## ARCHITECT'S SUPPLEMENTAL INSTRUCTIONS

<b>PROJECT:</b>	<b>Roosevelt Lofts</b> Historic Rehabilitation San Angelo, TX	<b>Report No.</b>	<b>Four (4)</b>
<b>OWNER:</b>	<b>Overland Property Group</b> 234 N. Santa Fe Ave, Suite A Salina, KS 67401	<b>Date</b>	<b>May 29, 2024</b>
<b>CONTRACTOR:</b>	<b>MCP Group</b> 3501 SW Fairlawn Rd. Topeka, KS 66614	<b>Architect's Proj No.</b>	<b>22-3281</b>
		<b>Contract For:</b>	General Construction Mechanical, Electrical

OCCUPANCY	USE	LOAD FACTOR	MAX. OCC LD=1 EXIT
B	COMMONS	15 sf/OCCUPANT	49
B	OFFICE	150 sf/OCCUPANT	49
B	MECH/ELEC	300 sf/OCCUPANT	49
R-2	APARTMENT	200 sf/OCCUPANT	10

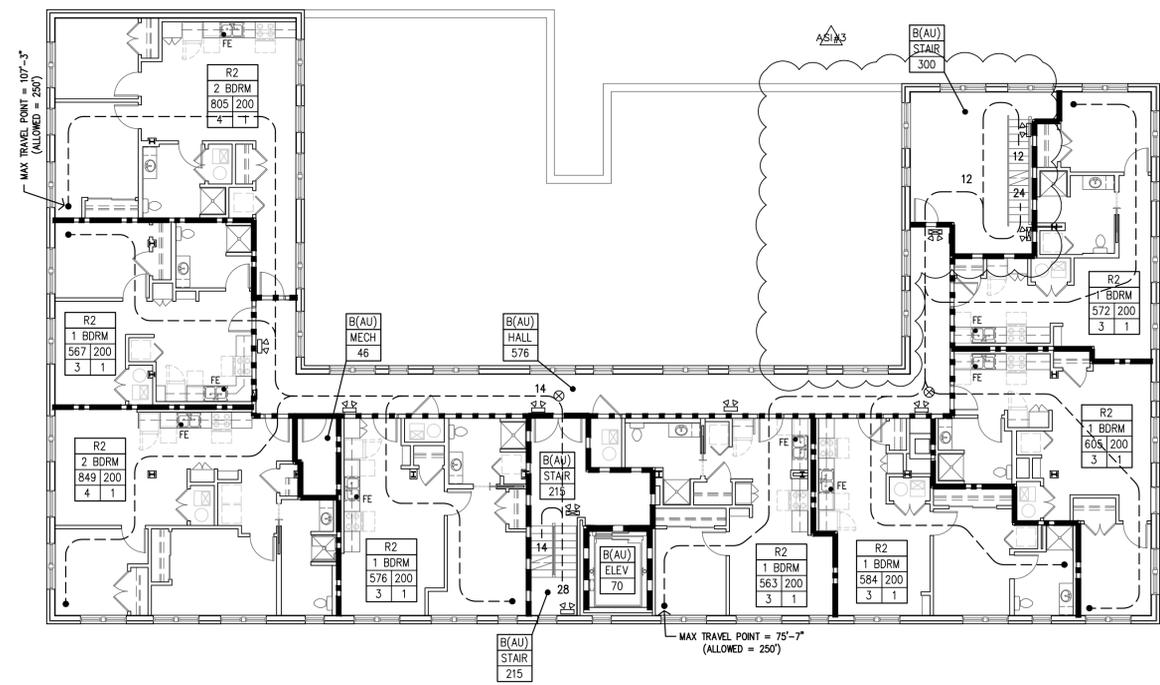
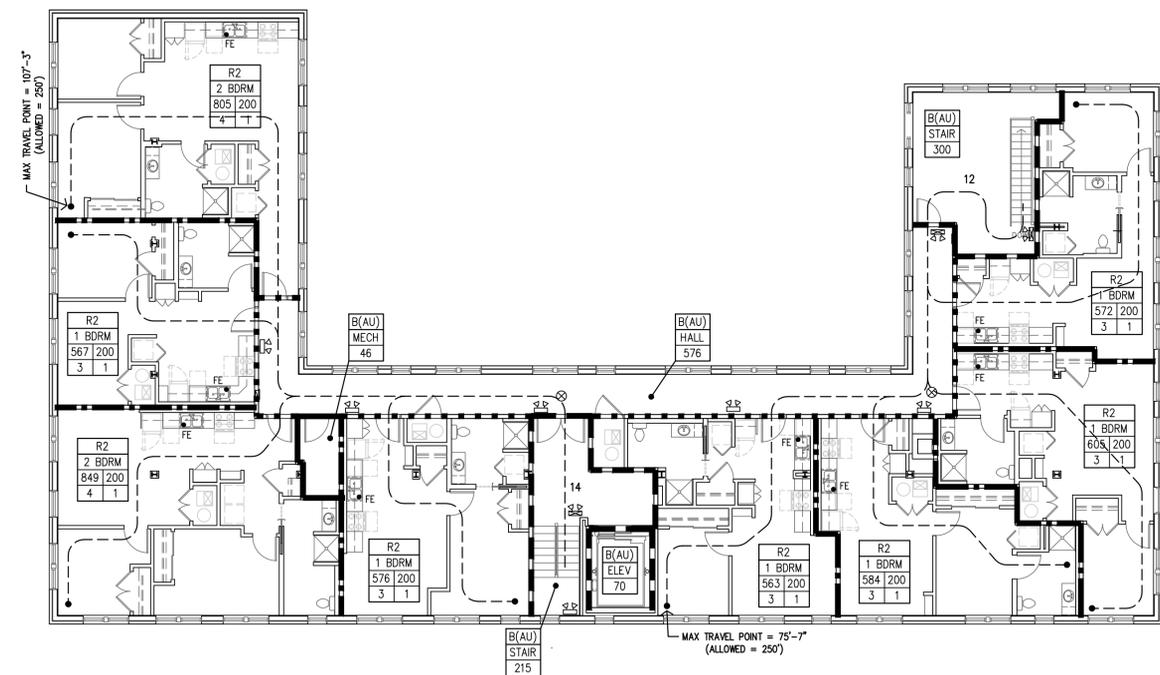
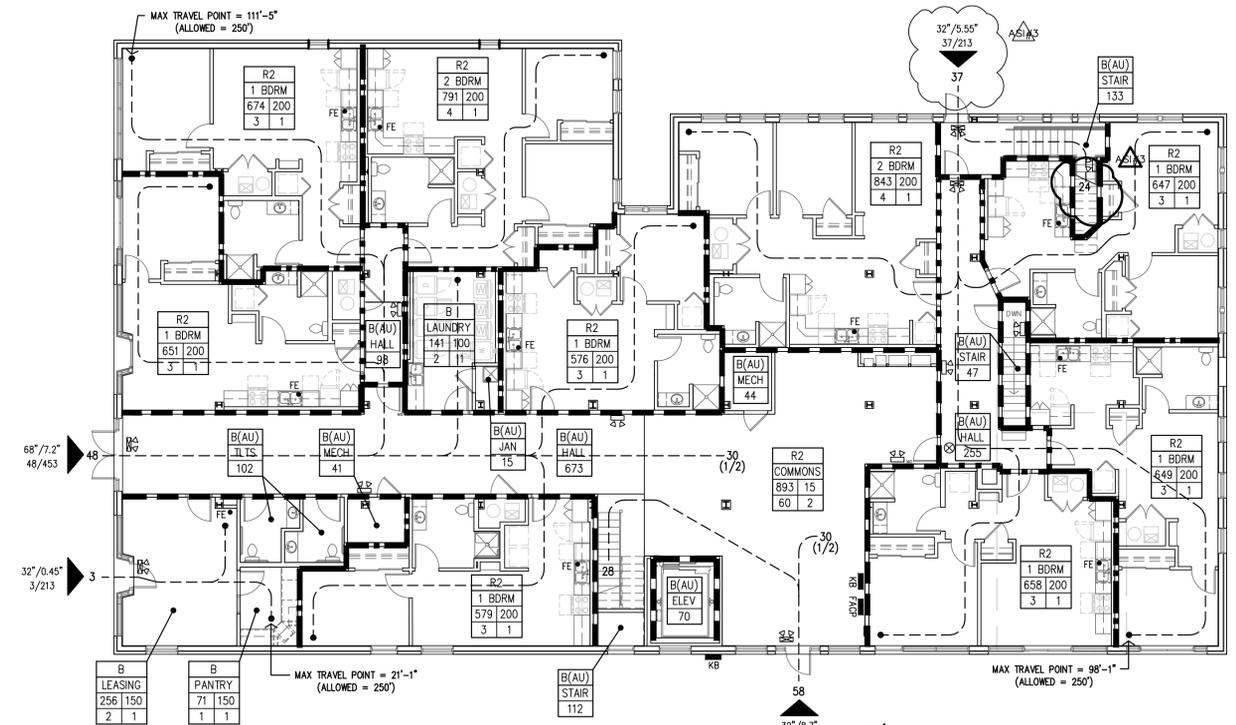
- a. Sheet CFP2 – Occupant Load Factor Chart has been updated to show 150 occupants/sf for Office Space.
  - b. Sheet A2.3 – A2.8
    - i. Elevator shaft size (width) has been reduced from 7'-8" (original designs) to 7'-4" to coordinate with elevator manufacturer's details/shop drawings. East wall of shaft shifts 4" to the west. The location of the west shaft wall does not change per the original designs.

A2.3

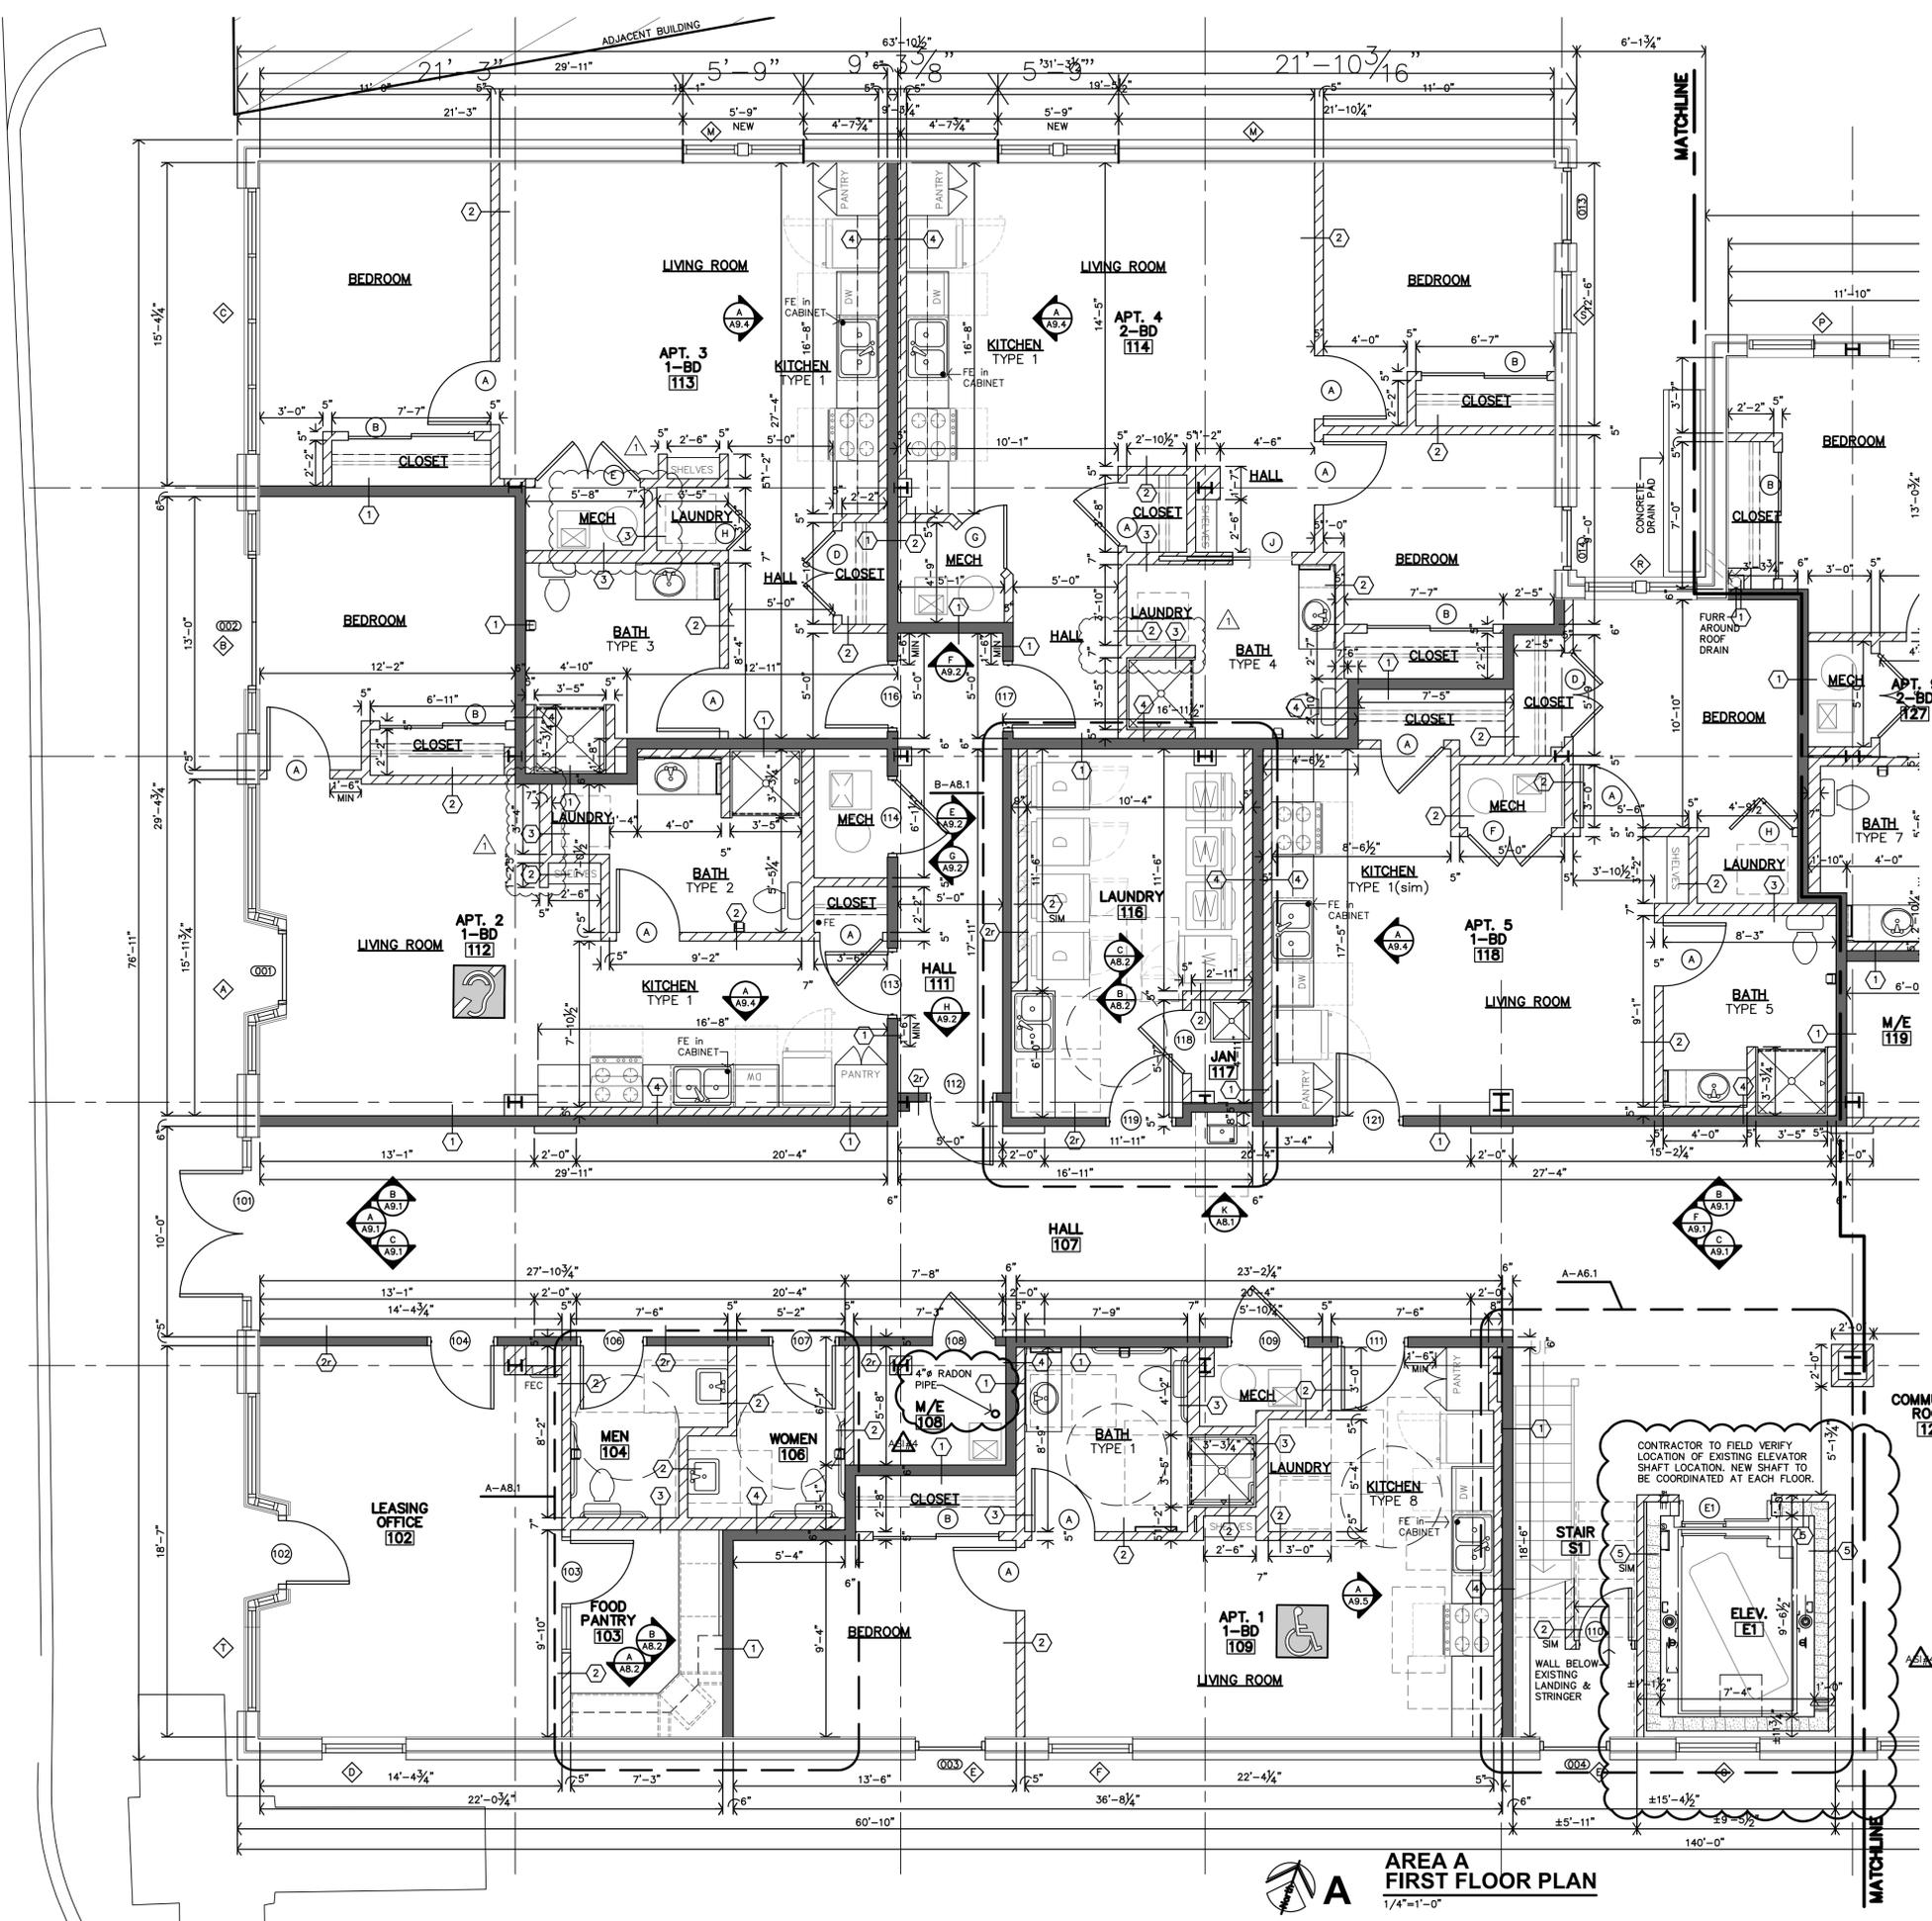
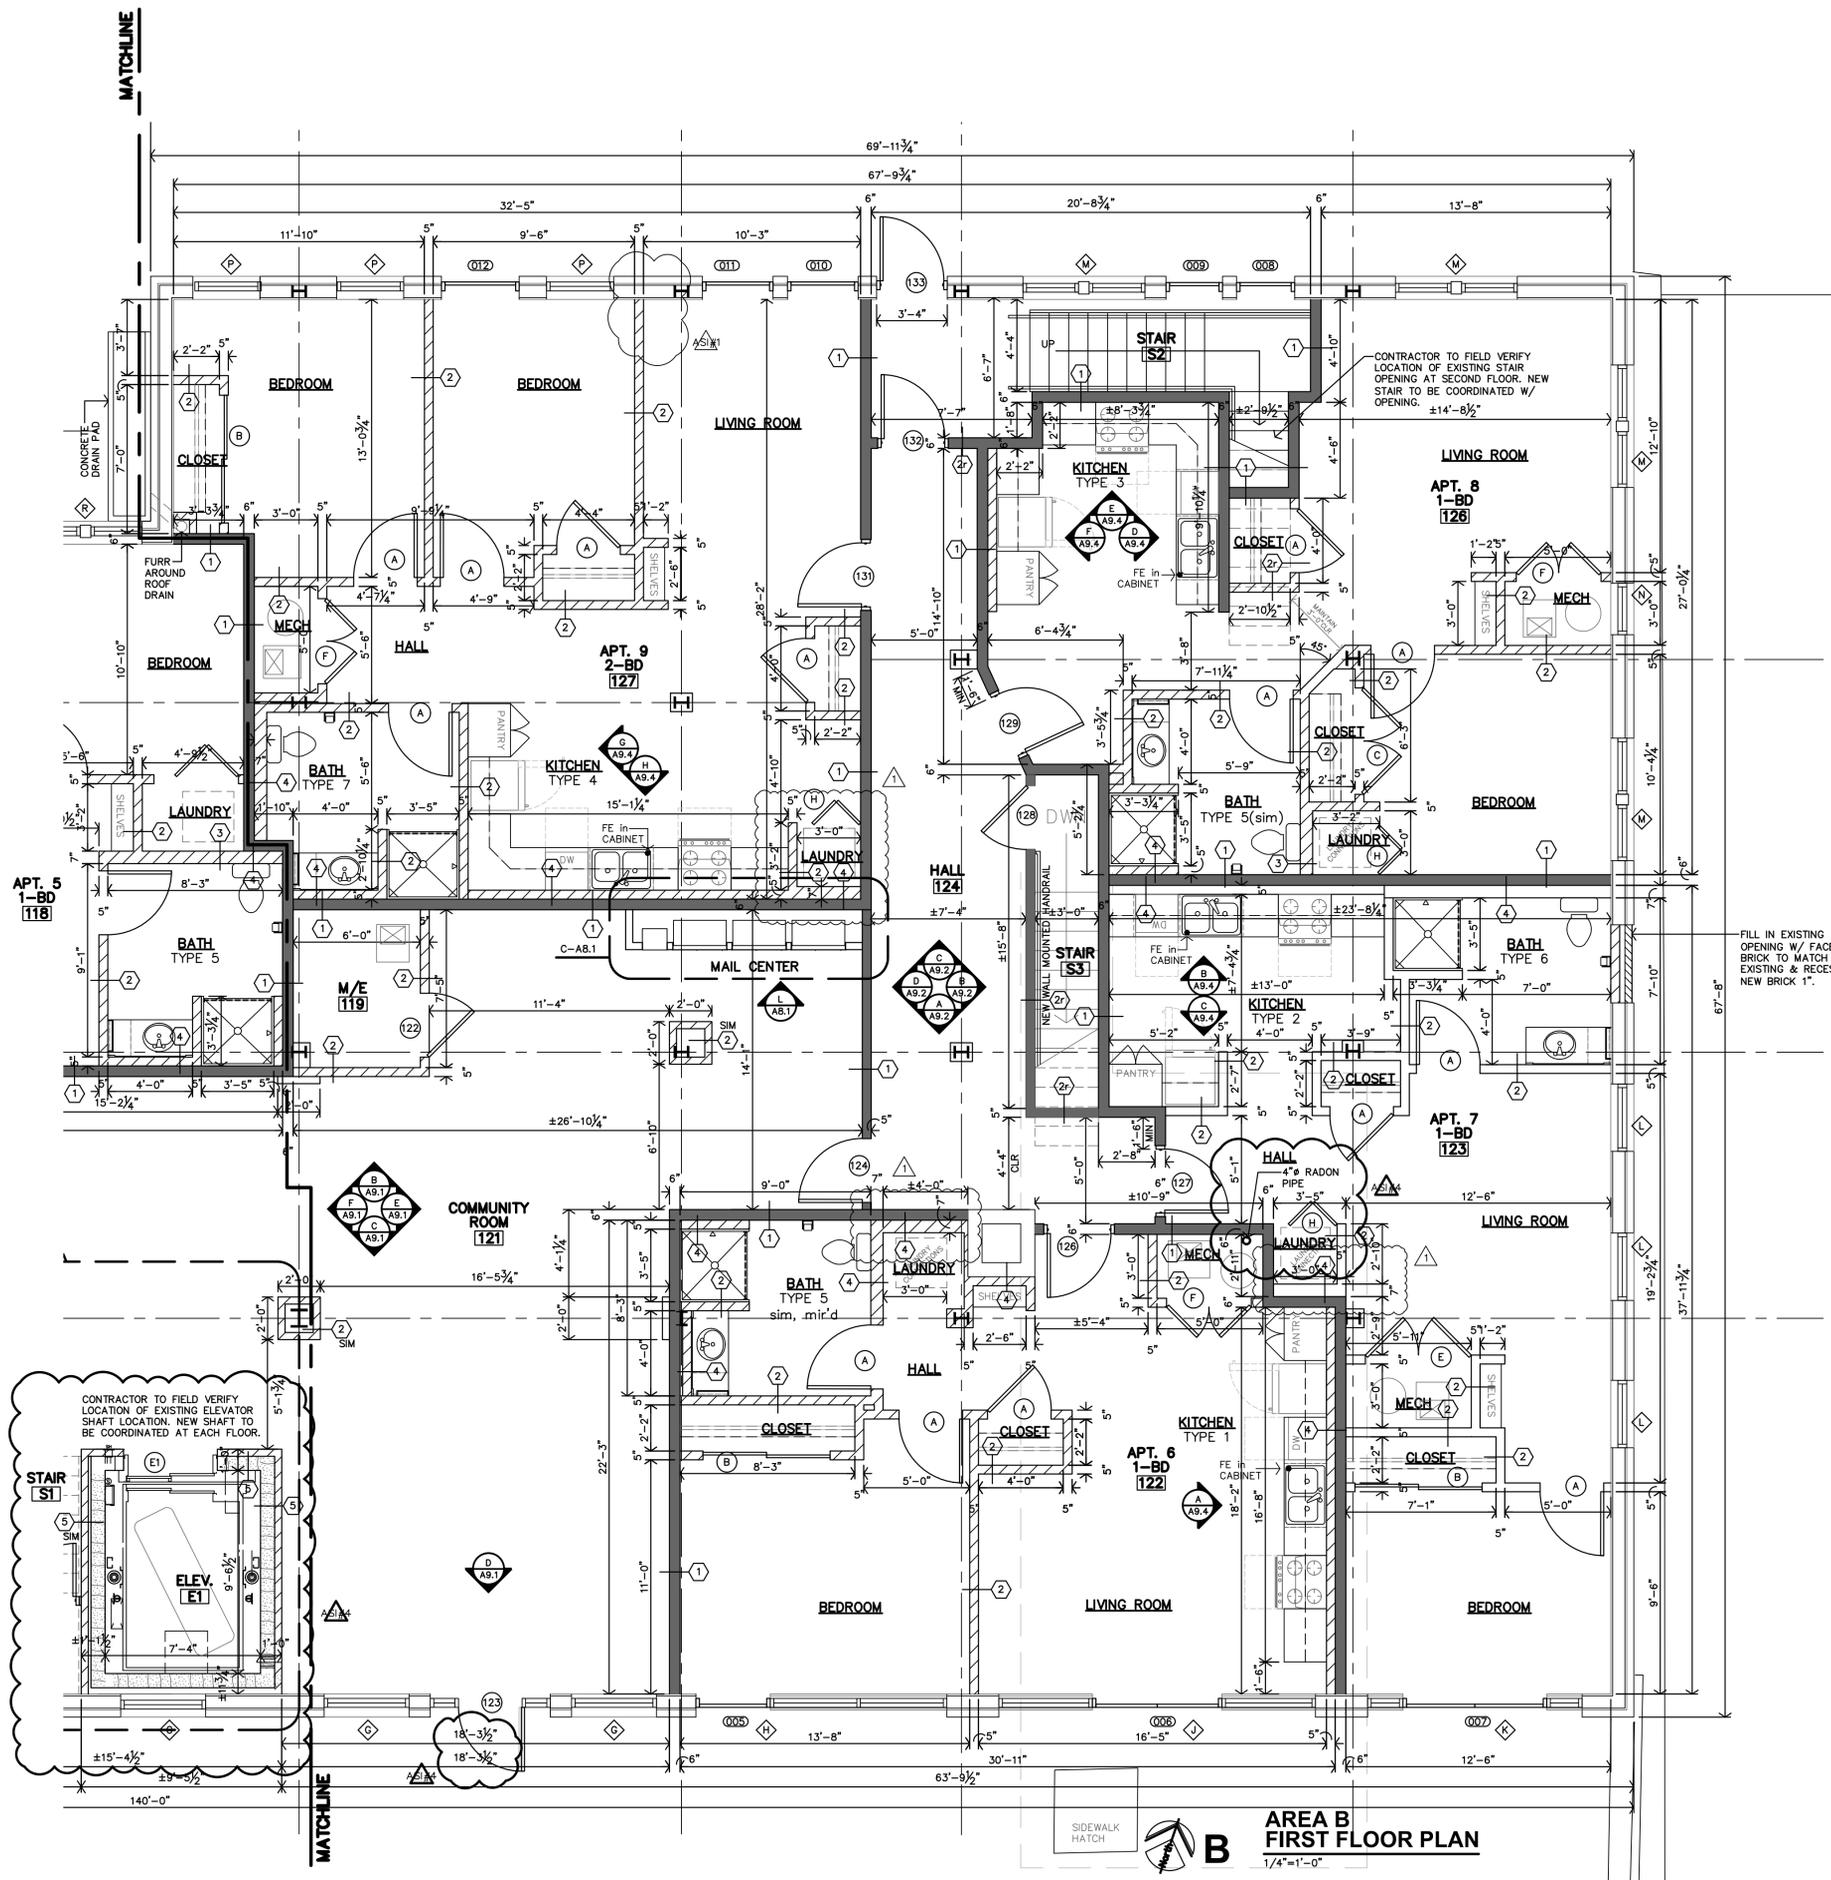
- c. Two radon pipes have been added to the building – Reference below sheets for locations, and attached sheet ASI 4.1 for section and details.
    - i. Sheet A2.3 – Added radon pipe in M/E #108.
